# METROPOLITAN GOVERNMENT OF NASHVILLE AND DAVIDSON COUNTY

## STAFF RECOMMENDATION 1504 Elmwood Avenue May 16, 2012

**Application:** Demolition, Infill, and New construction—accessory structure

**Description of Project:** Applicant proposes to demolish a non-contributing building and construct a one-and-a-half story dwelling with a detached rear accessory building.

1504 Elmwood - Rear Elevation -  $\frac{1}{4}'' = 1'-0''$

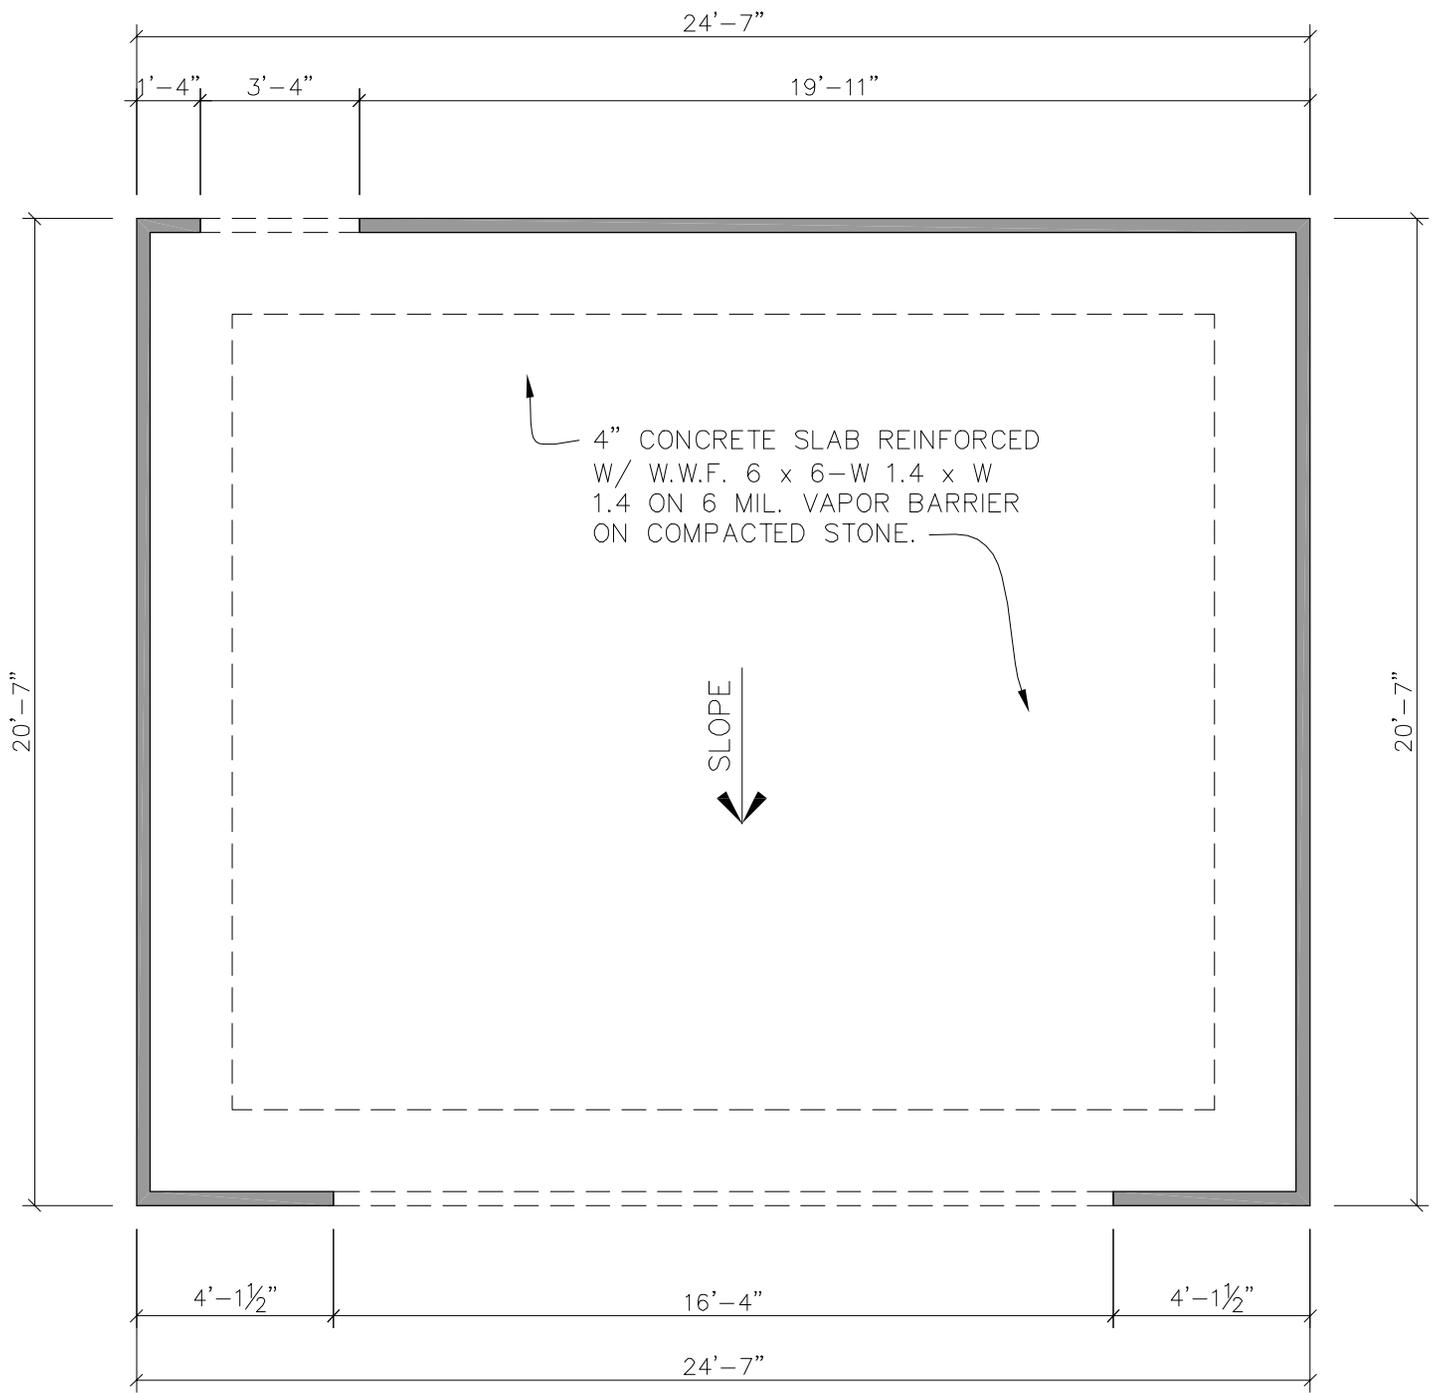
The front and side elevations show that the side dormers will have hipped roofs with a slope of 4/12, but the rear elevation shows that the side dormers will have hipped roofs with a slope of 8/12 and a 4/12 flare. Staff asks that a condition of approval be that a new rear façade drawing be submitted showing the side dormers with a 4/12 slope, which is a more appropriate roof slope than 8/12 for side dormers of this scale. The one-story rear extensions will also have hipped roofs with an 8/12 slope and a 4/12 flare.

These roof shapes and pitches are found on historic buildings throughout the district. With situating the front dormer two feet (2') from the porch rack and the submission of a corrected rear façade drawing showing a 4/12 roof slope for the side dormers, staff finds that the roof forms meet Section II.B.1.e. of the *Belmont-Hillsboro Neighborhood Conservation Zoning Overlay Handbook and Design Guidelines*.

FRONT ELEVATION  
SCALE: 1/4" = 1'-0"

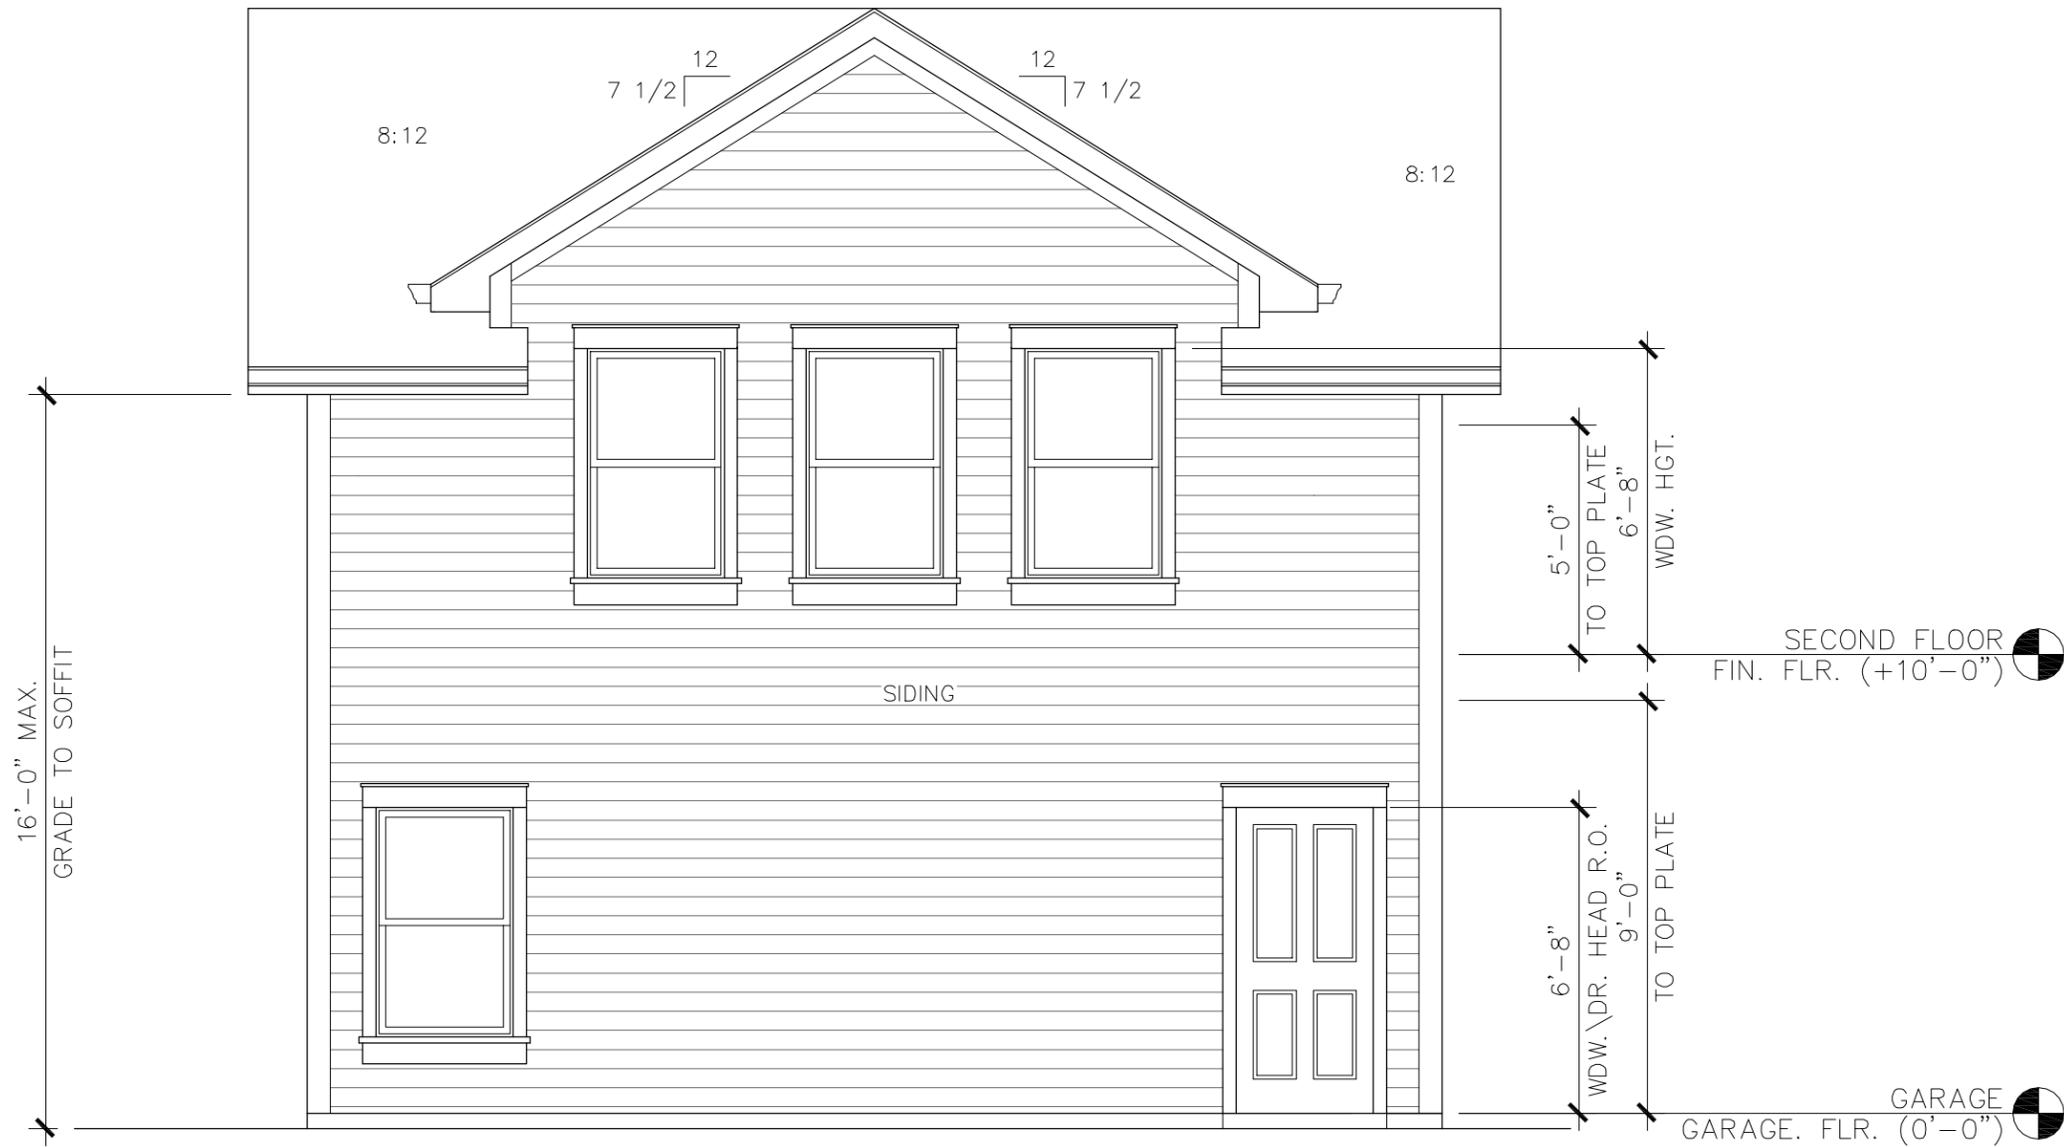
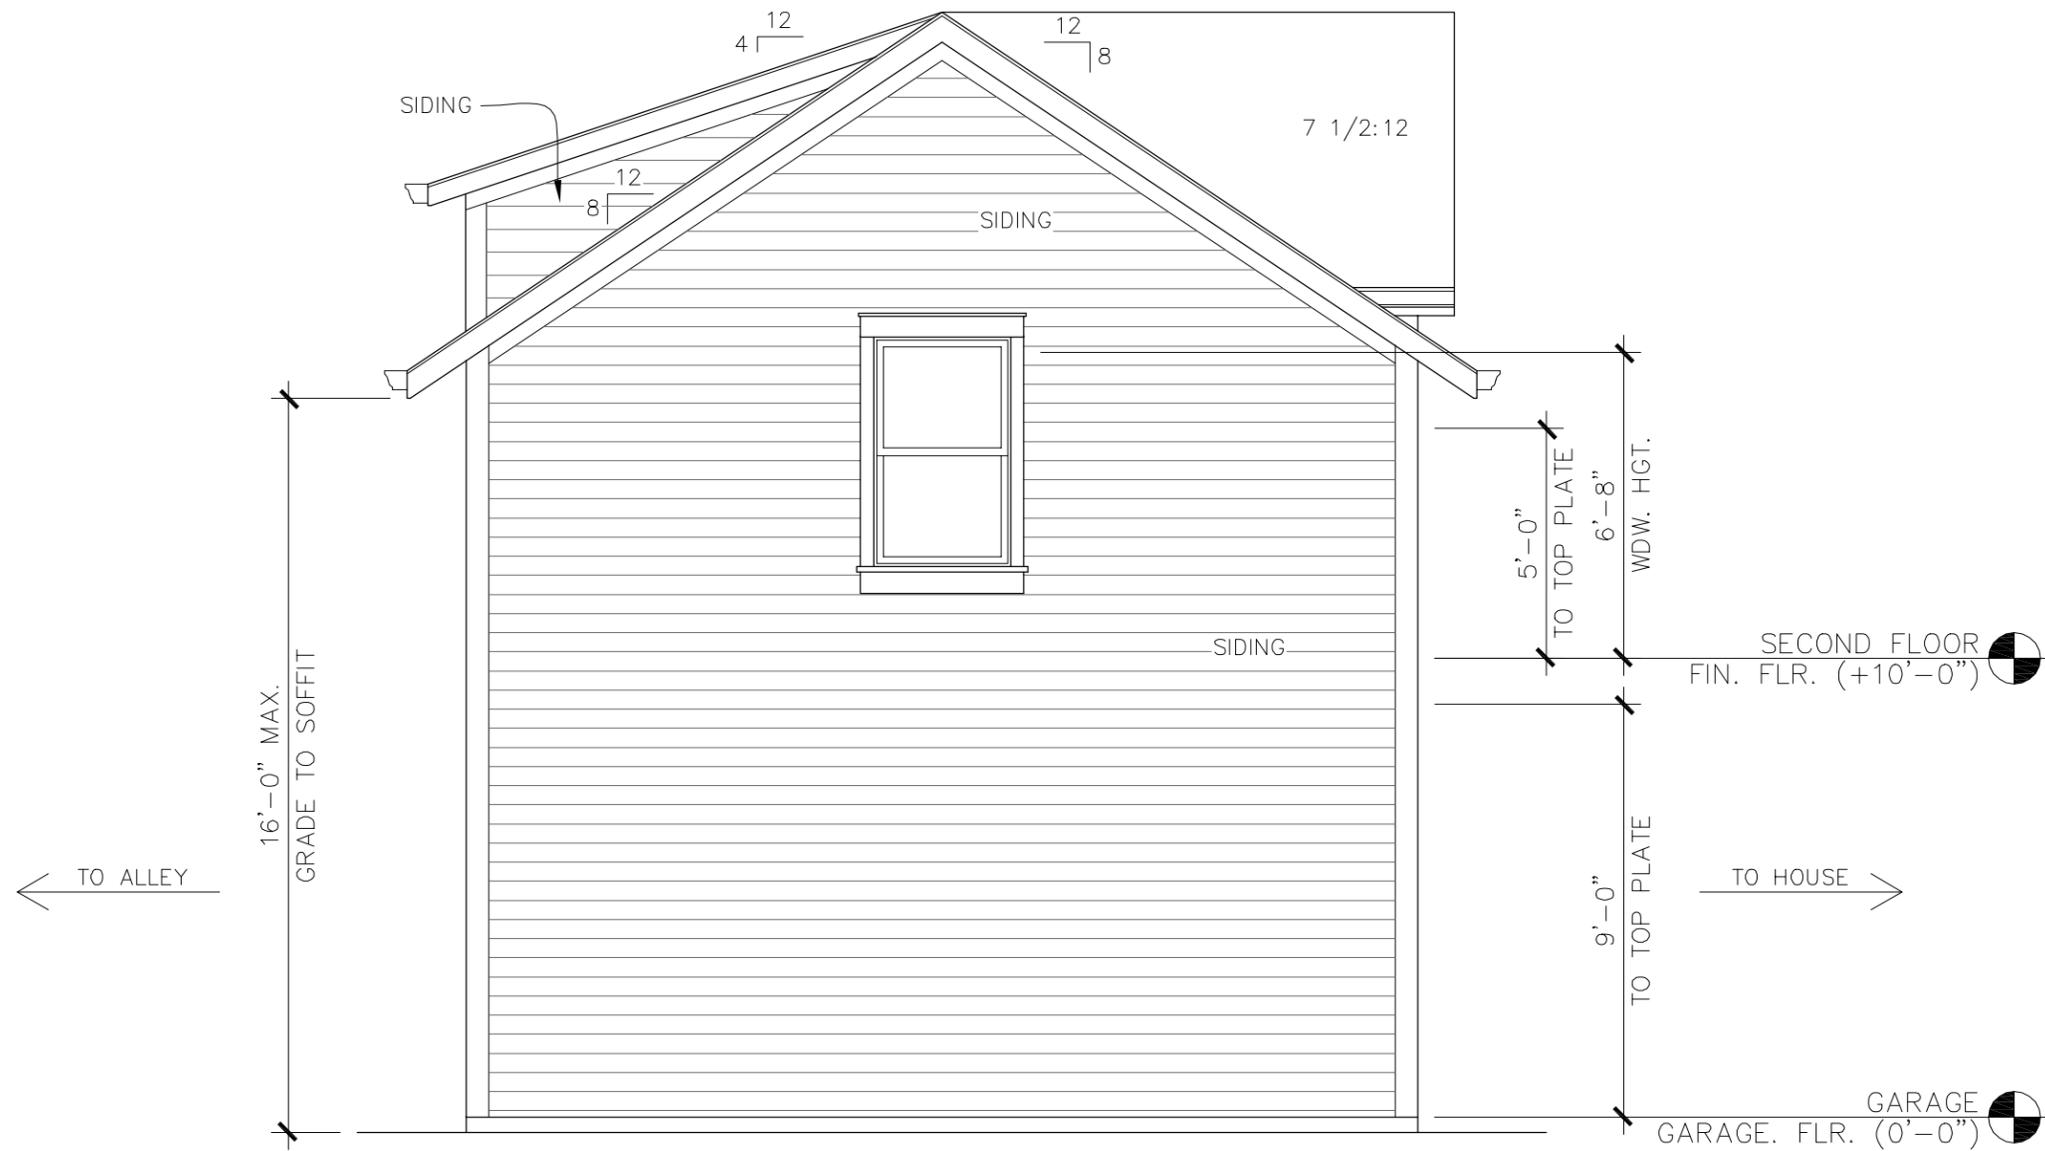
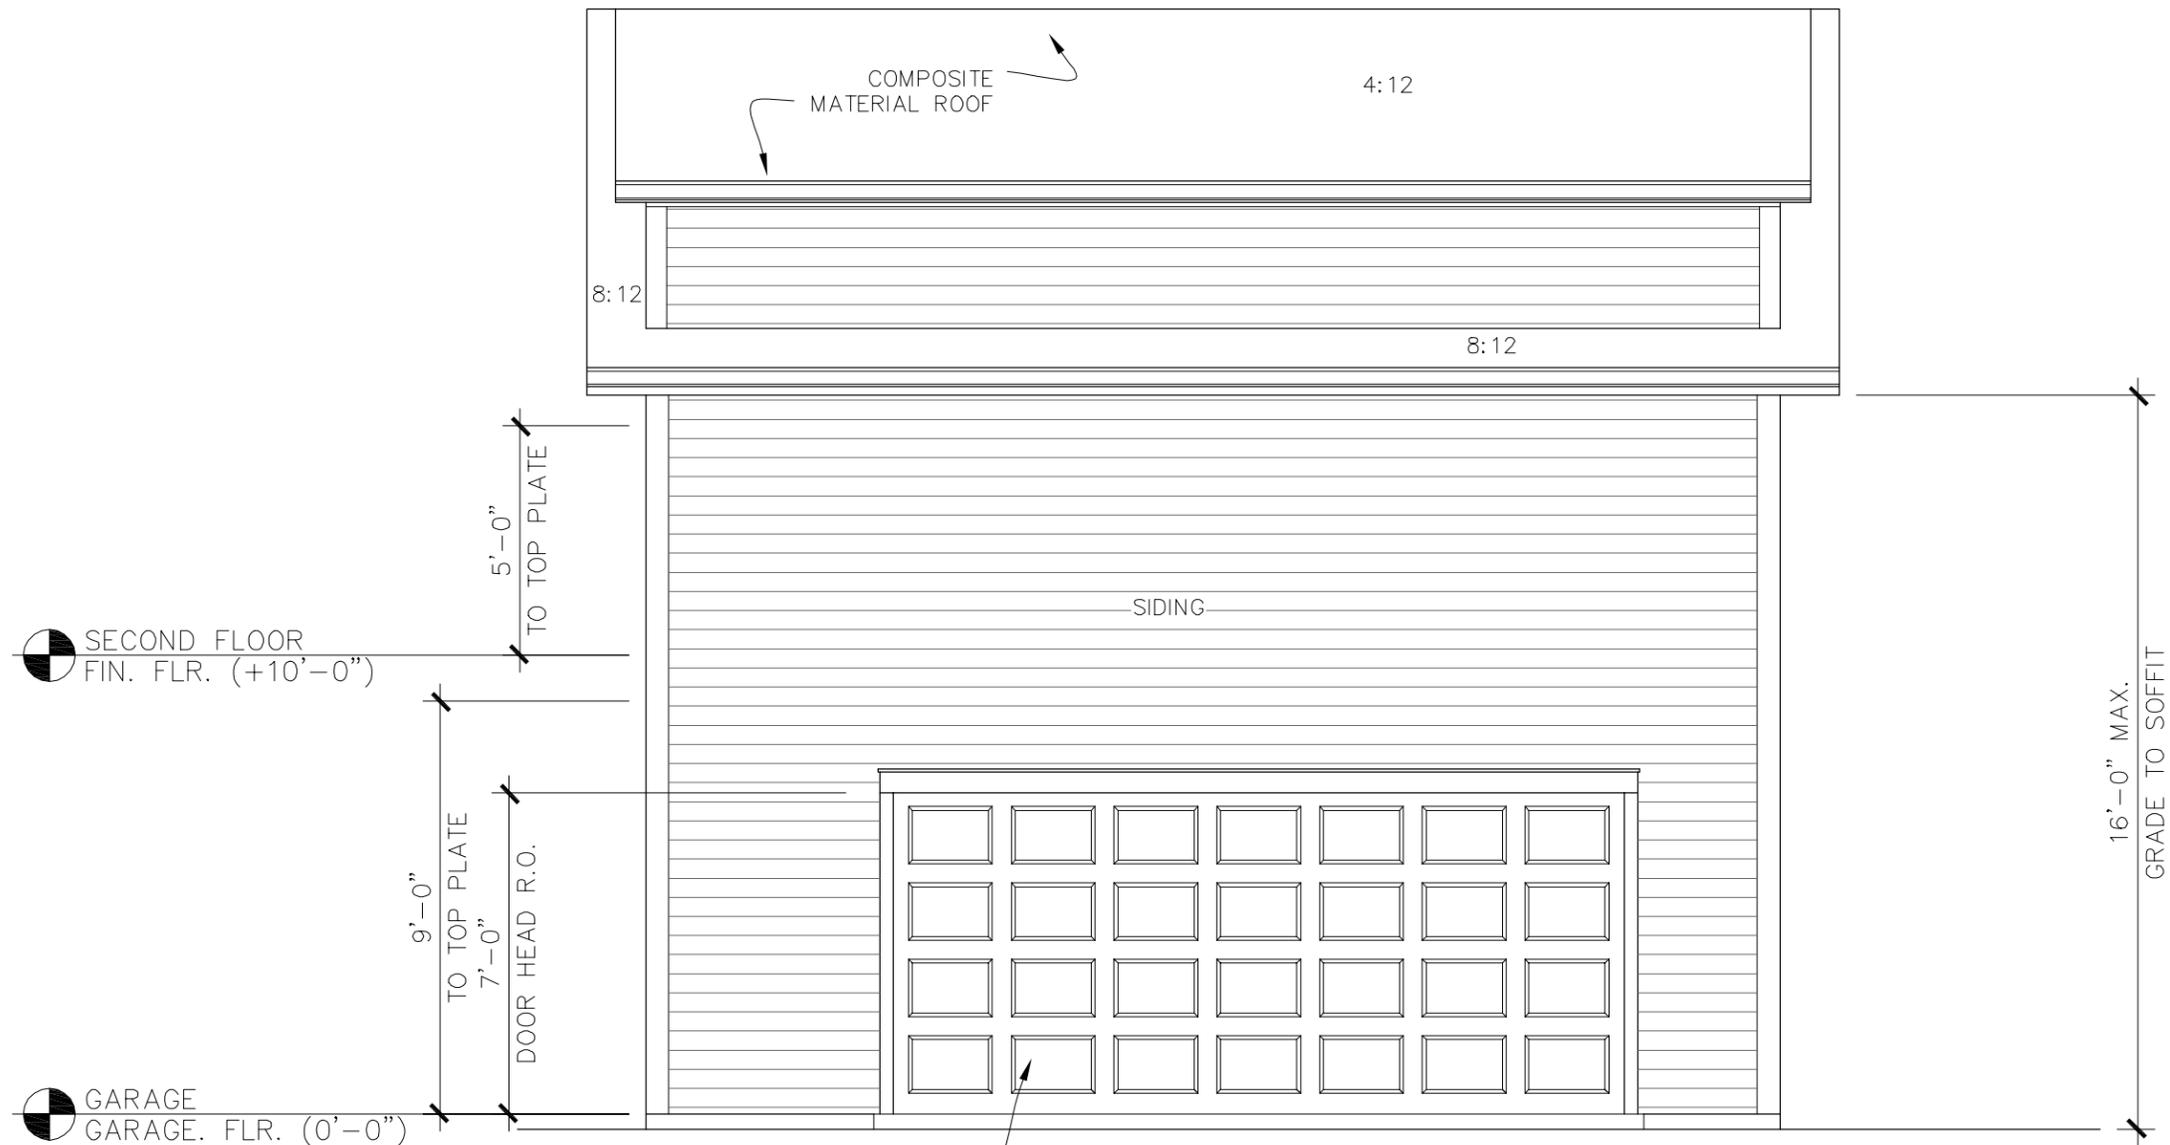
The accessory structure is proposed to have an eave height of sixteen feet (16') and a ridge height of twenty-four feet, six inches (24'6"). Staff finds that the height of the accessory structure is not subordinate to the proposed infill, which will have an eave

height of twelve feet, nine inches (12'9") and a ridge height of twenty-six feet, nine inches (26'9"). Staff asks that both the ridge height and the eave height of the accessory structure be lowered by a minimum of two feet (2'), which, in conjunction with the slope of the site, will help to ensure it is subordinate to the primary structure. In addition, staff asks that a trim board be added to the garage at the floor level to help minimize the perceived height of the structure.

With the reduction of the eave and ridge height by a minimum of two feet (2'), the addition of the trim board, and the staff's final approval of the windows and doors, staff finds that the proposed accessory structure meets Section II.B.1.i. of the *Belmont-Hillsboro Neighborhood Conservation Zoning Overlay Handbook and Design Guidelines*.
